**PETITION OF THE
NORTH AMERICAN ELECTRIC RELIABILITY CORPORATION
FOR APPROVAL OF PROPOSED RELIABILITY STANDARD PRC-025-1
(GENERATOR RELAY LOADABILITY)**

September 30, 2013

Exhibit A	Proposed Reliability Standard PRC-025-1 (Generator Relay Loadability)
Exhibit B	Implementation Plan
Exhibit C	Order No. 672 Criteria
Exhibit D	Consideration of Issues and Directives
Exhibit E	Analysis of Violation Risk Factor and Violation Security Level
Exhibit F	Summary of Development History and Complete Record of Development
Exhibit G	Standard Drafting Team Roster for Project 2010-13.2 Phase 2 Relay Loadability: Generation

Figure 4. Relay Connection for corresponding synchronous options.

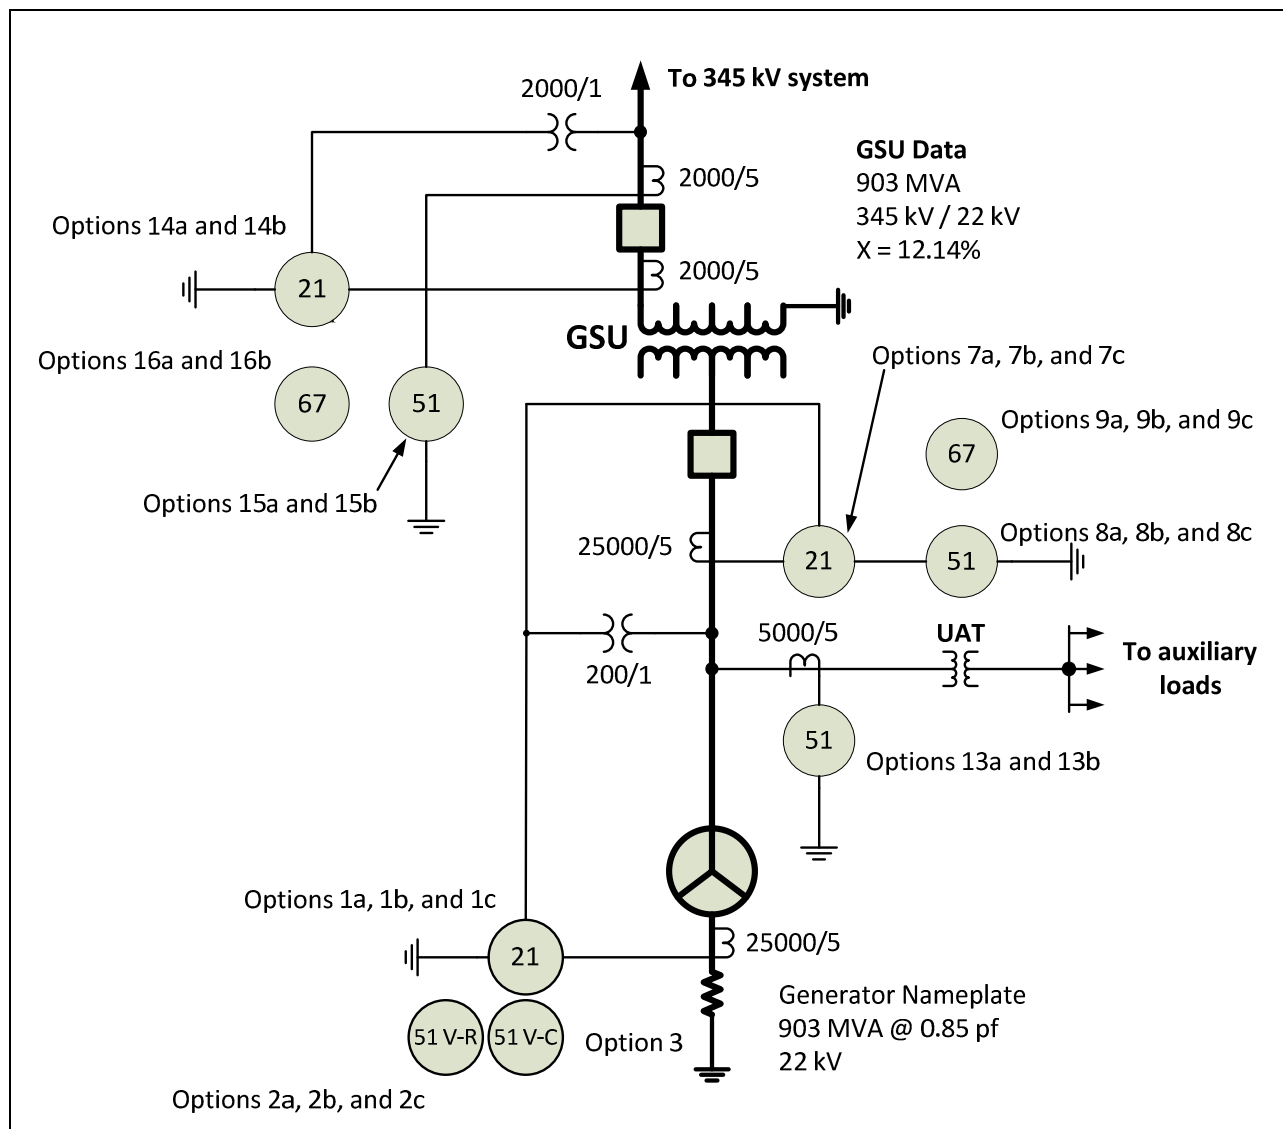
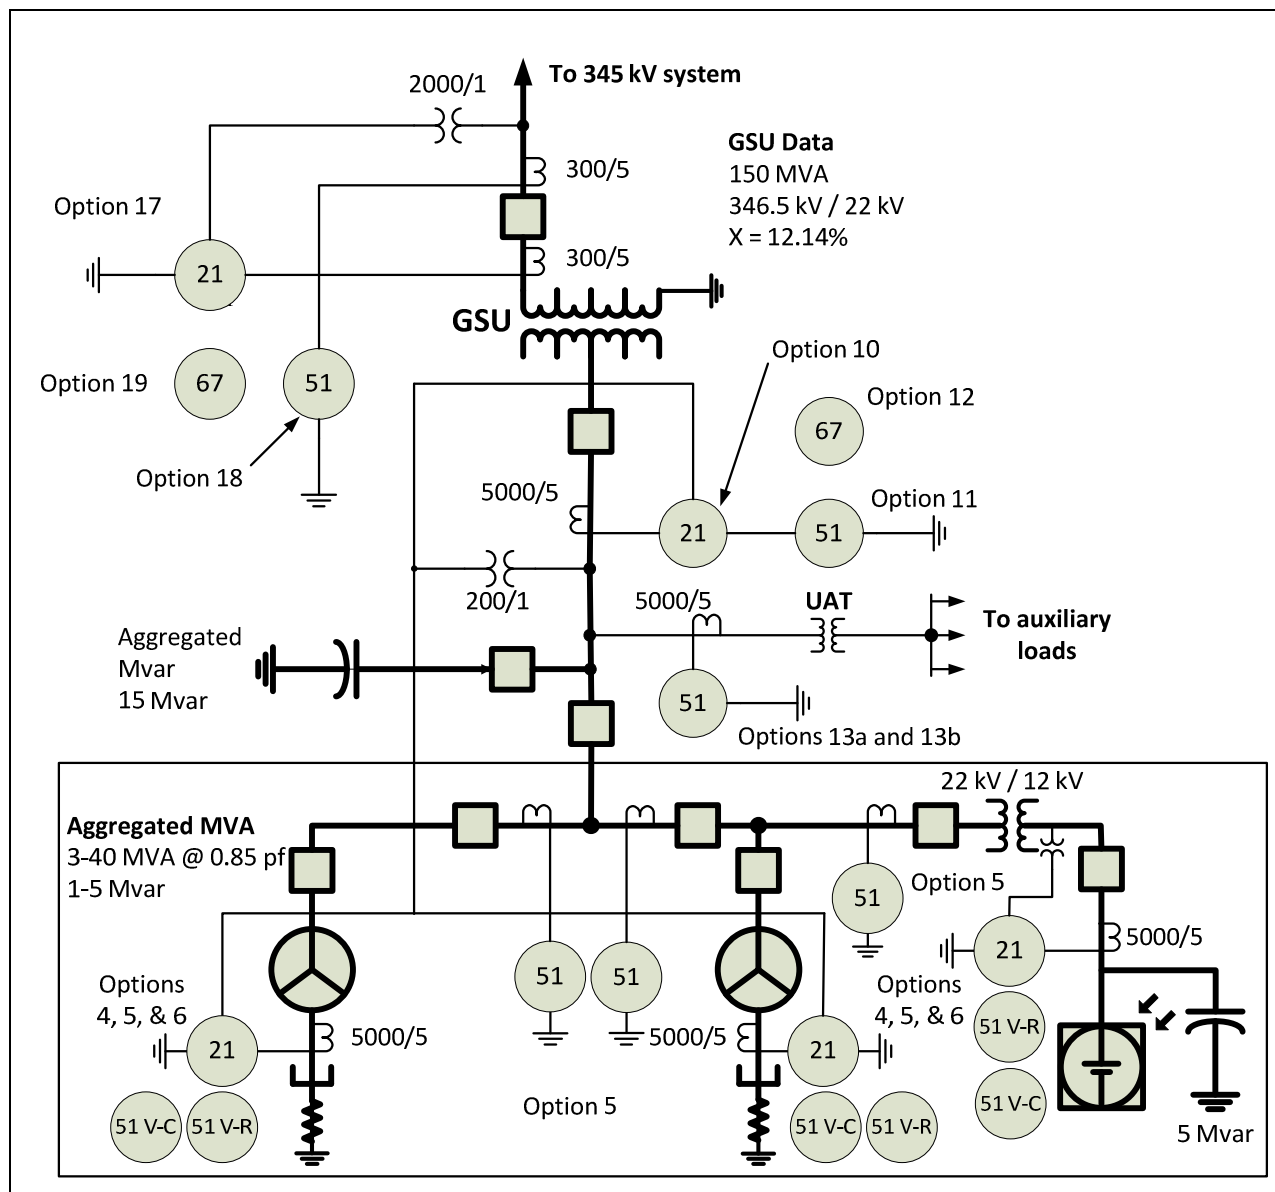
Organization	Yes or No	Question 3 Comment
		<p>2) In Figures 4 and 5 the CT's supplying the 21, 51V-R and 51V-C relays connected to the generator(s) look like they are connected to the generator neutral. To make it clear that they are supplied from CT's connected in the phase leads, a phase to neutral transition symbol (ref Fig 7.4 in IEEE C37.102) should be used to indicate the CTs are located above the neutral connection point.</p> <p>Response: Figures 4 and 5 have been modified to address this concern. Change made.</p> <p>3) In Figure 5 there is a 51 relay shown connected to the 22kV bus leads supplying the generator on the left hand side of the drawing. This 51 relay is not revered, or used, in any of the options and therefore should be removed from the drawing.</p> <p>Response: Figure 5 and Table 1, Option 5 has been revised to address this concern. Change made.</p> <p>4) Options 14a, 14b, 15a, 15b, 16a and 16b all use an MVAR value equal to 120% of the aggregate generation MW value, instead of the 150% value used when the relays are located on the generator side of the GSU transformer. Presumably this is to account for the I squared Xt MVAR loss consumed in the GSU transformer. However, there is no mention of this fact in the Guidelines and Technical Basis document. To avoid confusion as to why different MVAR criteria are used, supporting technical justification / explanation should be offered in the document.</p> <p>Response: The assumption is correct. Discussion has been added to the Guidelines and Technical Basis. Change made.</p> <p>5) The example calculations for Options 4 and 10 are combined as a single identical set of calculations. This calculation is appropriate for Option 10 but not for Option 4. Referring to Figure 5, the 21 relays for Option 4 are shown connected to each individual generator. Also the 20MVAR static compensation source is connected upstream of each generator relay. As such, the 21 relay on each individual generator (Option 4) will only see the MW and MVAR flows from a single generator, not the aggregate of all the generation plus the 20MAR reactive source. A separate</p>

Figure-1 –Auxiliary Power System (Independent from Generator)

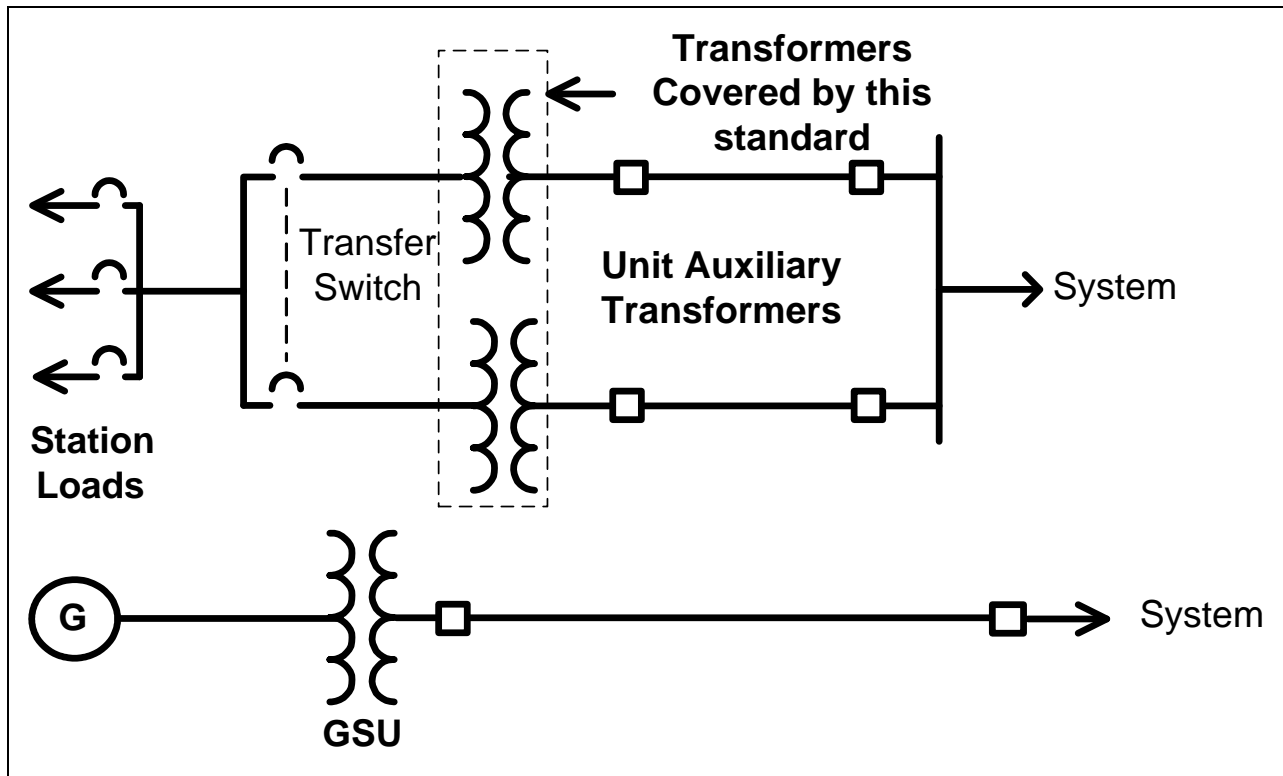
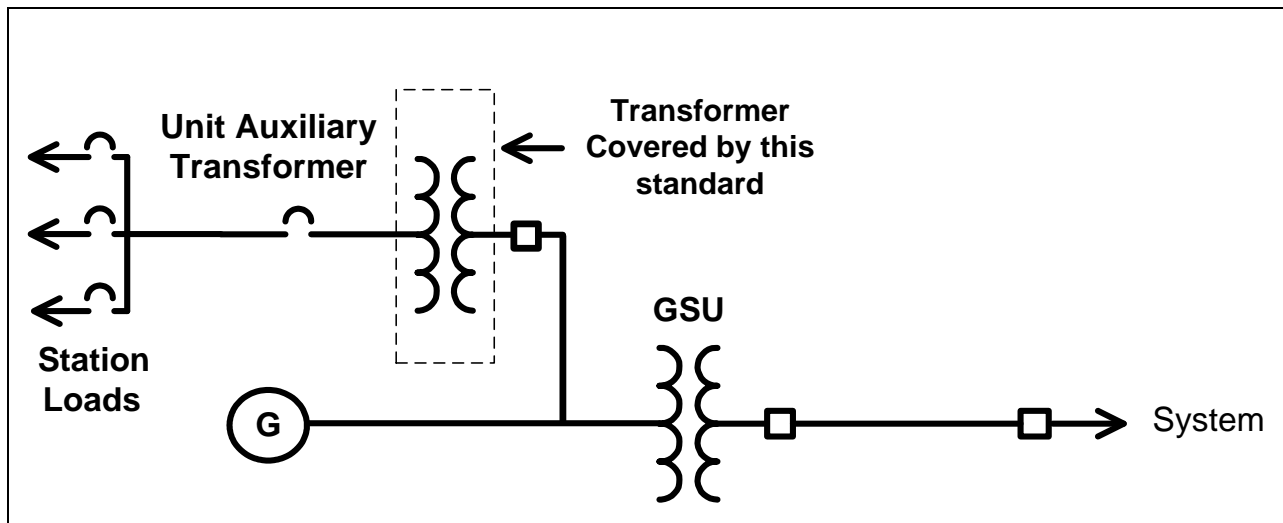
Considering Figures 1 & 2, it is unclear whether the intent is to include station auxiliary transformers that feed plant loads when the unit is offline or in the process of startup. An exception should be made for transformers that do not feed plant loads during normal unit online operation.

<p>South Carolina Electric and Gas</p>	<p>No</p>	<p>Considering Figures 1 & 2, it is unclear whether the intent is to include station auxiliary transformers that feed plant loads when the unit is offline or in the process of startup.</p> <p>Response: The drafting team believes the standard provides sufficient clarity to which unit auxiliary transformers (i.e., UAT) load-responsive protective relays are applicable and that an exception is not necessary. Only the unit auxiliary transformers (i.e., UAT) load-responsive protective relays which are used to provide overall auxiliary power to the generator station when the generator is running (i.e., on-line) are applicable to the standard. Refer to the Applicability section (3.2.3), the accompanying footnote #1 and the unit auxiliary transformers section of the Guidelines and Technical Basis for additional information. No change made.</p> <p>An exception should be made for transformers that do not feed plant loads during normal unit online operation.</p> <p>Response: The drafting team notes that in Section 3.2.3 of the Applicability section and the related footnote 1 “Auxiliary transformer(s) that supply overall auxiliary power necessary to keep generating unit(s) online.” addresses this issue. No change made.</p>

Organization	Yes or No	Question 2 Comment
		<p>Response: The drafting team notes that Figures 1 and 2 are examples of unit auxiliary transformer (UAT) connection configurations. No change made.</p>
<p>Response: Thank you for your comments, please see the responses provided above.</p>		
MRO NSRF	No	<p>Recommend the phrase “while maintaining reliable protection” be removed as it introduces ambiguity into R1. Although the SDT attempts to clarify the phrase within the “Guidelines and Technical Basis”, the NSRF is concerned that the phrase’s inclusion will only result in future requests for Interpretation as entities are forced to explain and defend their desired protection goals. Rather than rely on the “Guidelines and Technical Basis”, we recommend the following changes to R1 be made:</p> <p>R1. Each Generator Owner shall install settings that are in accordance with PRC-025-1 - Attachment 1: Relay Settings, on each load-responsive protective relay while maintaining reliable protection.</p>
